REQUEST FOR BIDS

Emergency Generator Purchase and Installation

RFB 25BCP10C

ADDENDUM #1

TITLE
BASETANK
1940 GALLON TOTAL/1822 GALLON USEABLE
EXT F-GROUP

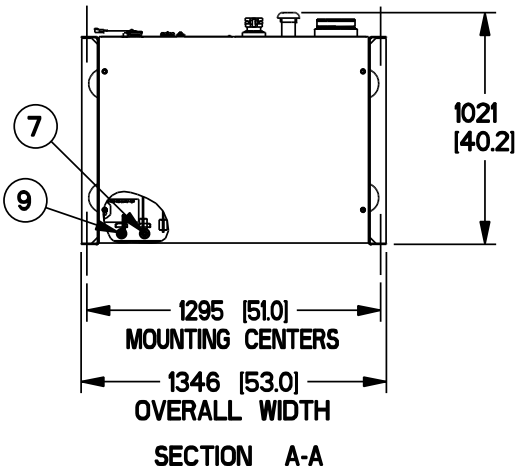
Q: The bid sheet specifies a 774-gallon tank for the generator but drawing ES-101 indicates a 72-hour tank. The 72-hour tank would be much larger than 774 gallons. Can you please clarify which one is required?

A: The basis of the design is Generac, other manufacturers' tanks vary in size. Please see the attached drawing from Generac. We used the dimensions reflected on the attached document in the request for Proposal documents. Generac provided this specific tank based on the information we provided them with, such as a minimum 72-hour running time.
